RATTLE NOISE FROM INSTRUMENT PANEL AND/OR CREAK NOISE FROM A-PILLAR OVER ROUGH / BUMPY ROADS

Bulletin No: 09-002/14**Last Issued:** 10/03/2014**BULLETIN NOTE**

Rattle Noise From Instrument Panel:

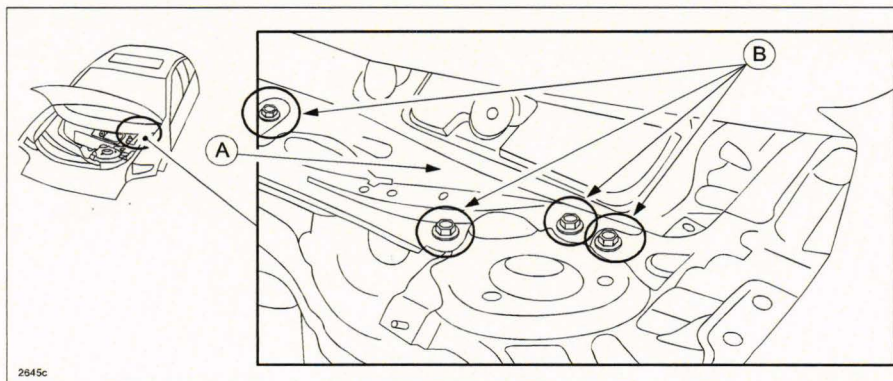
The rattle noise may be caused by low cowl panel (A) mounting bolt (B) torque.

Creak Noise From A-Pillar:

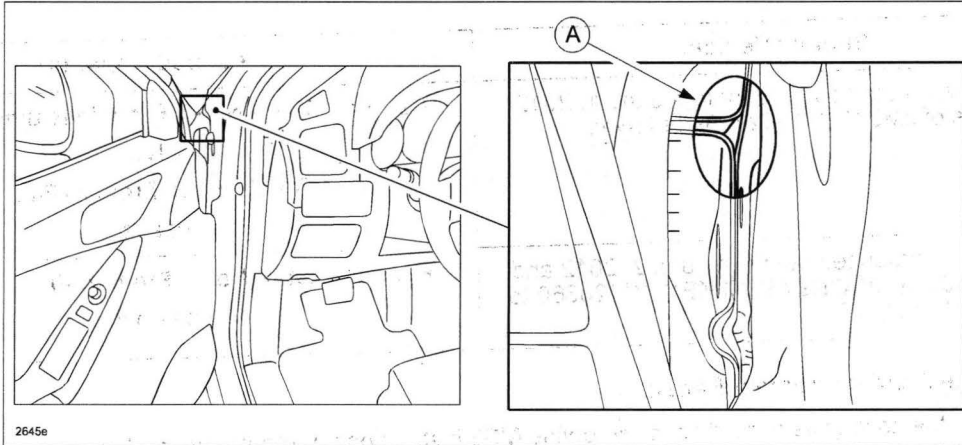
This noise may be caused by two joined panels (A) scraping together at the A-pillar. The panel weld areas have been improved during the mass-production of vehicles with VINs JM3KE*****128359 (produced June 1, 2012) or higher.

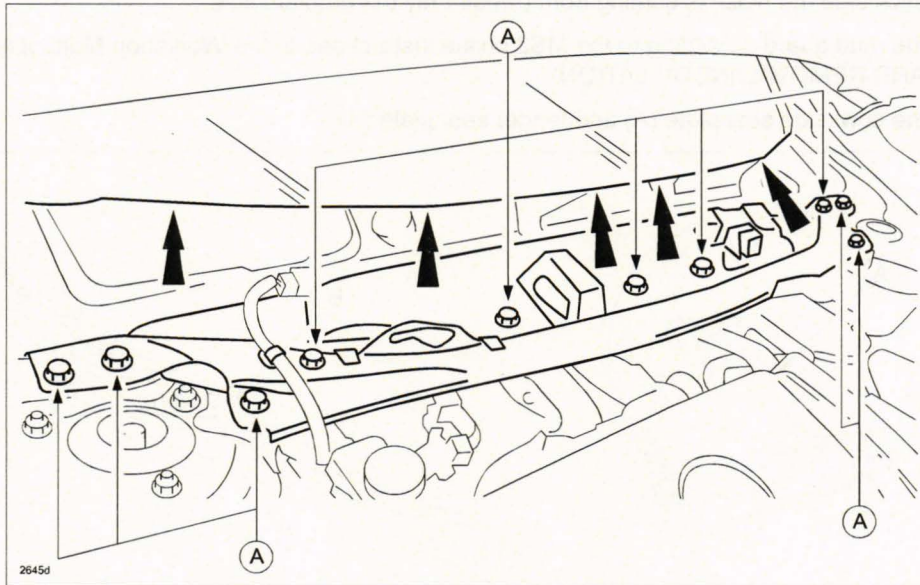
CAUTION: To avoid damaging the windshield, be sure to apply adequate protection along the bottom edge of the glass (i.e. tape or a sliced rubber hose) before retightening the cowl panel bolts.

2. Retighten all ten (10) cowl panel bolts (A) to:
Tightening Torque: 17-22 ft. lbs {22-30 Nm, 2.3-3.0 kgf-m}
3. Reinstall the cowl grille according to the online MS3 instructions or the Workshop Manual (section 09-16 COWL GRILLE REMOVAL/INSTALLATION).

Creak Noise From A-Pillar:

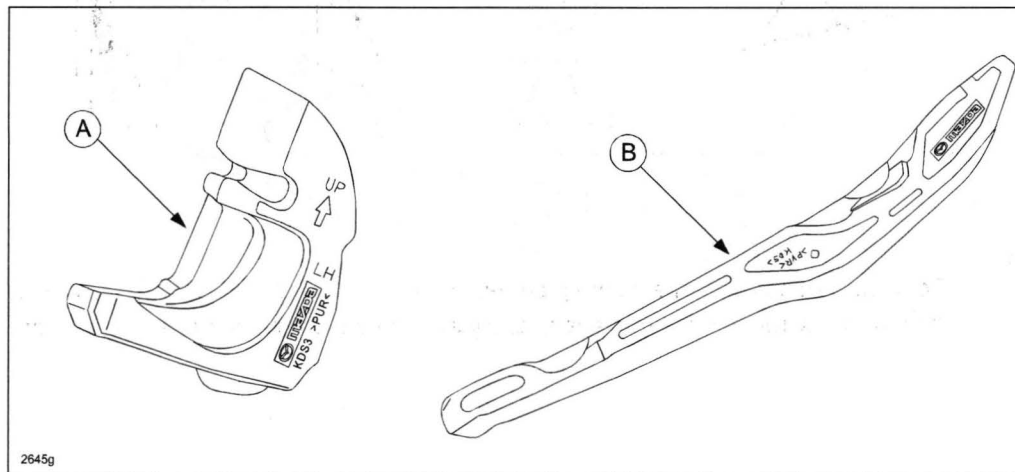
Enlarge the clearance between two (2) panels (A) using an appropriate tool (i.e. flat-blade screwdriver).

NOTE: In the illustration (below, right), the front fender is removed for viewing purpose only. It is not necessary to remove the front fender for this repair.

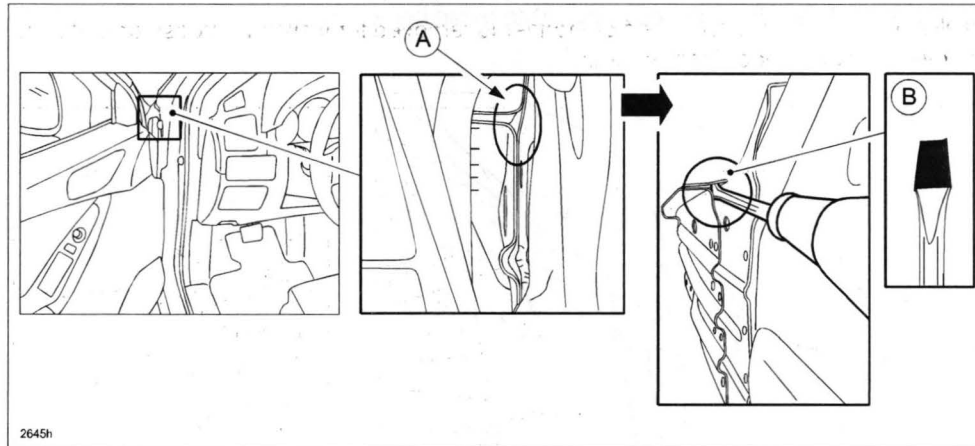
1. Identify which side the noise is coming from (repair only the problem side).
2. Remove the mud guard according to the MS3 online instructions or the Workshop Manual (section 09-16 MUD GUARD REMOVAL/INSTALLATION).
3. Remove the cowl side seal plate (A) and fender seal plate (B).

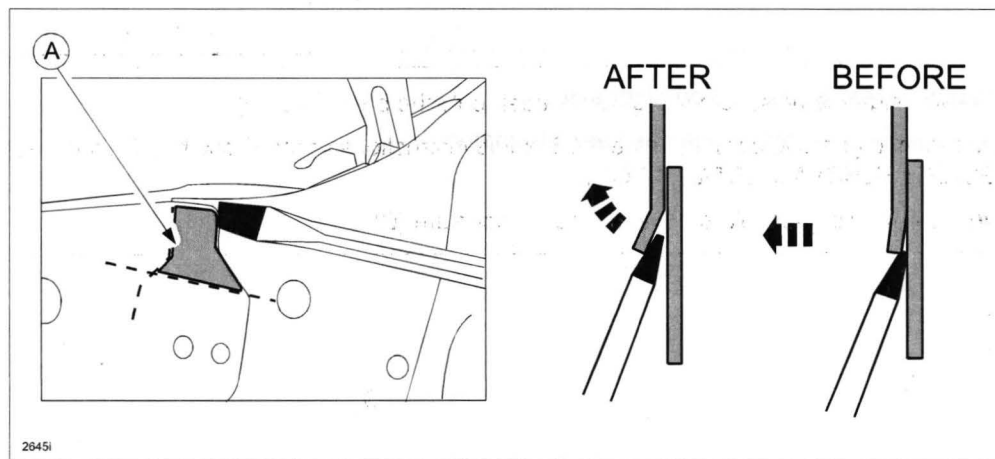
4. Open the front door and place a flat-blade screwdriver with protection tape on the tip (B) between the two panels at joint (A).

5. Bend the cowl side reinforcement panel (A) to create a clearance of more than 1 mm between the panels.

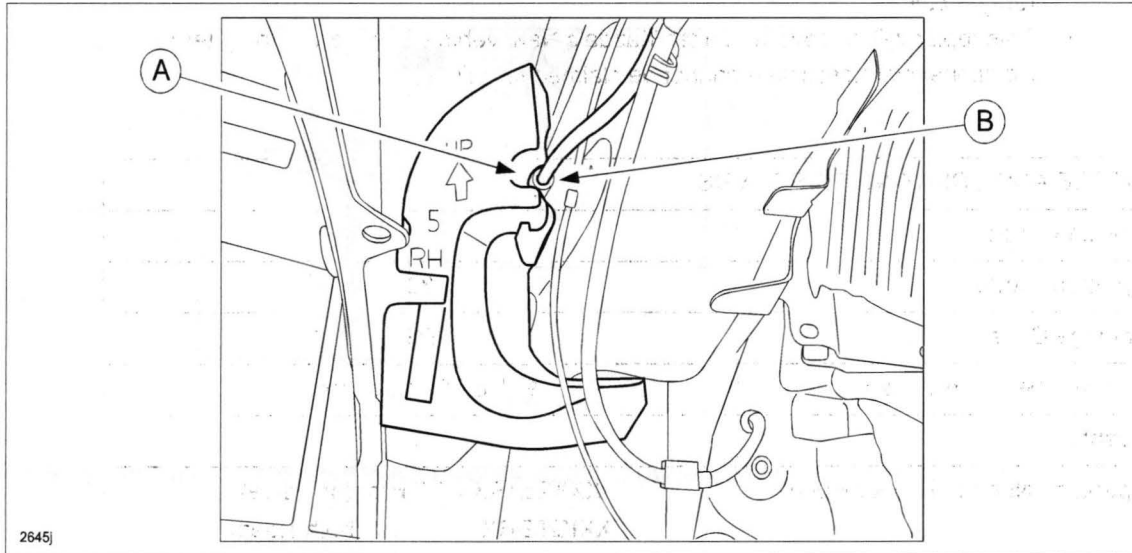
NOTE: Passenger Side Only: When reinstalling the cowl side seal plate, make sure to install the rear window washer hose (B) in the opening (A) to avoid hose damage.
